Service Bulletin No: 27-014

Modification No: EC-19-0030, EC-20-0054

**FLIGHT CONTROLS - PITCH CONTROL
INTRODUCTION OF ADDITIONAL TRIM TAB BALANCE MASS ON THE ELEVATORS**

Replacement of the Elevator Trim Tab Weight on the Left and Right Elevator Trim Tabs
Figure 1

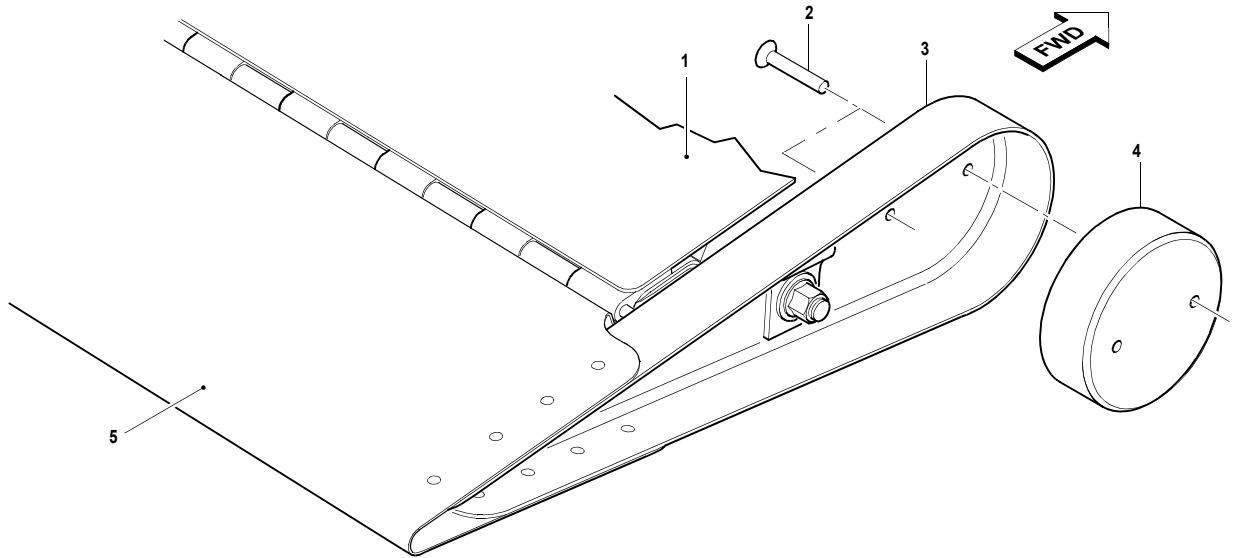
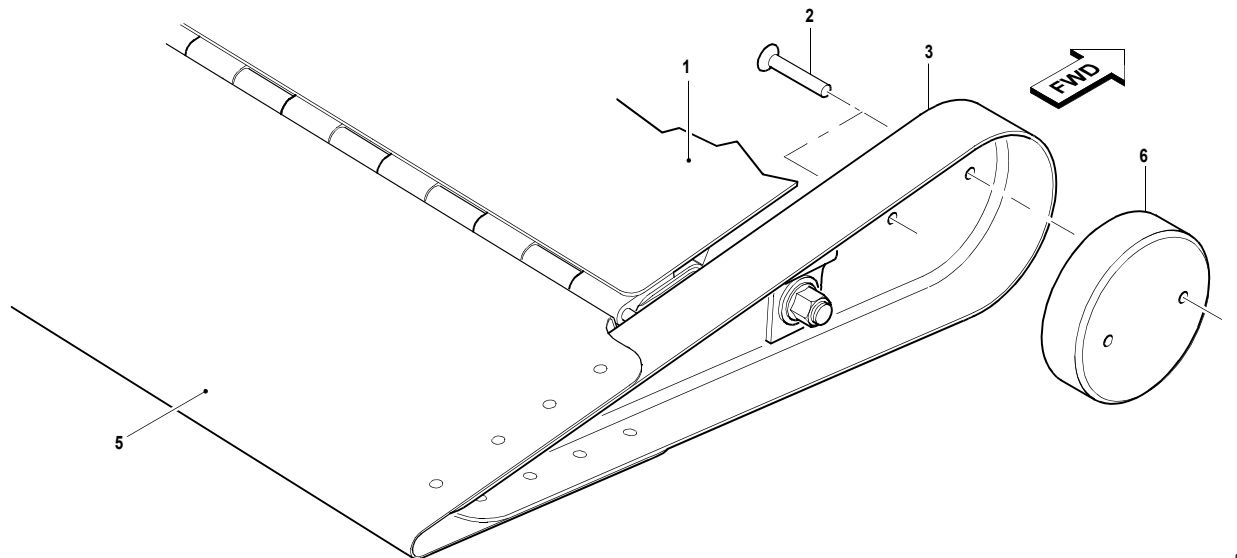
An issue has been identified which results in dynamic instability in the extremely unlikely event of a disconnected elevator tab. This can be removed by an increase in the mass balance weight of the elevator trim tabs.

- The elevator trim tab balance weight is replaced with a heavier balance weight that gives a weight increase of 55 g per tab
- An additional lead disk is added to the elevator mass balance assembly to keep the correct balance after the modification to the trim tab. The mass of the lead disk (55 g) may need adjustment during the balancing procedure.

- (1) Do the modification to replace the elevator trim-tab balance-weight (Ref. Fig. 1).
 - (a) Move the elevator trim tab assembly (3) and hold in the deflected position to get access to the balance weight (4).

- 4 Use absorbent paper (Material No. P02-031) made moist with solvent (Material No. P01-010) to clean the work area.
 - (c) Install the new balance weight (6) (Pos. No. 10) on the elevator trim tab assembly (3).

- 1 Apply a layer of sealant (Material No. P08-094) on the mating surfaces of:
 - The new balance weight (6) (Pos. No. 10)
 - The elevator trim tab assembly (3).

- 2 Put the new balance weight (6) (Pos. No. 10) in position.
 - 3 Use the gripper pins/clamps (or equivalent) to help hold the new balance weight (6) (Pos. No. 10) in position.

- 4 Apply a layer of sealant (Material No. P08-094) on each rivet before you install it.
 - 5 Install two new rivets (2) (Pos. No. 110) to attach the new balance weight (6) (Pos. No. 10) in position.
